CITY PLANNING COMMISSION

- APPLICATION:
- A. Variance to waive the required six foot high masonry wall along the west property line.
 - B. Variance to allow a four foot high fence along the west property line in the front setback (withdrawn by staff).

LOCATION: 2009 V Street

PROPOSAL: The applicant is requesting the necessary entitlements to allow an existing six foot high wood fence along the west property to remain.

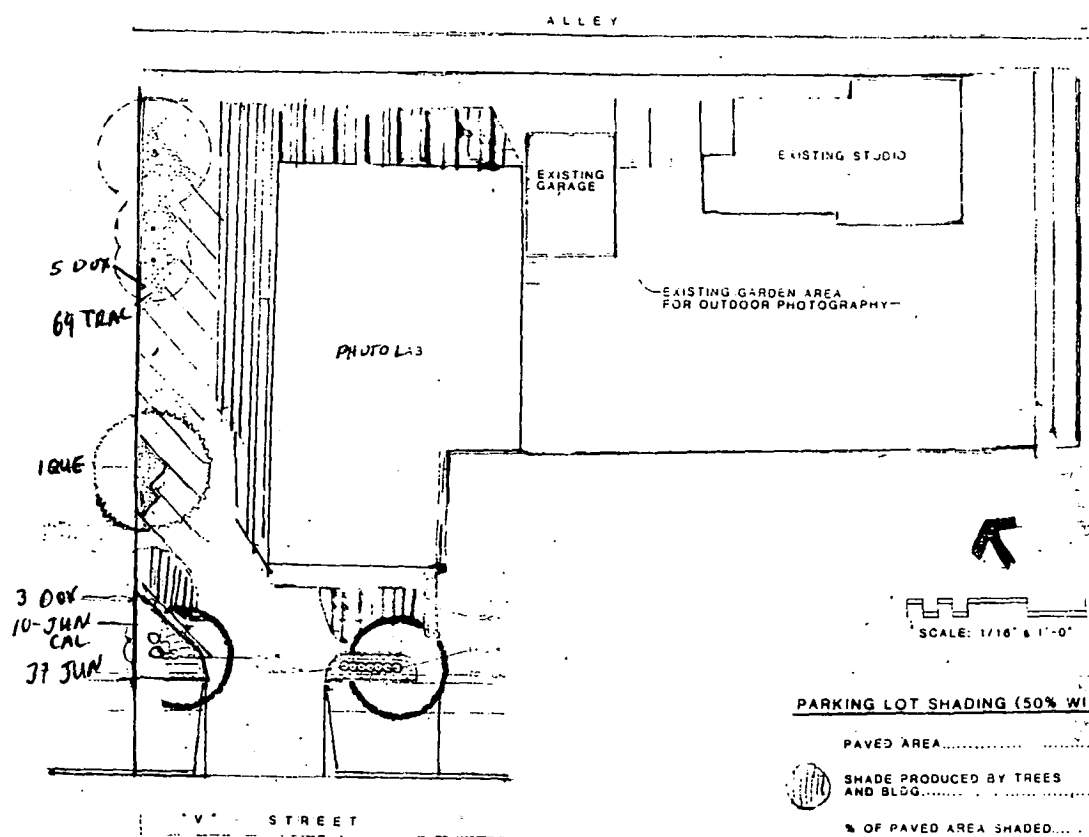
4. Landscape and irrigation plans were approved by the Design Review Board in 1981 as shown in Exhibit D. However, upon a recent site inspection, it is apparent that much of the landscaping is missing. The one and five gallon juniper shrubs (two types) called out in the planters along the south property line will need to be replanted, and the vines called out in the planters along the west property line should be replaced. The vines are "Cats Claw" vines which are intended to grow along the face of the wood fence. A California Live Oak (24 inch box) is also missing from the centrally located planter along the west property line.

1. The specific size, location and type of plants called out in the landscape and irrigation plans dated April 22, 1982 and approved in 1981 by the Design Review Board shall be planted (include irrigation) prior to issuance of the final occupancy permit for the photo lab.
2. The Planning Director shall inspect the site for compliance with replanting condition prior to issuance of final building approval and issuance of occupancy permit.
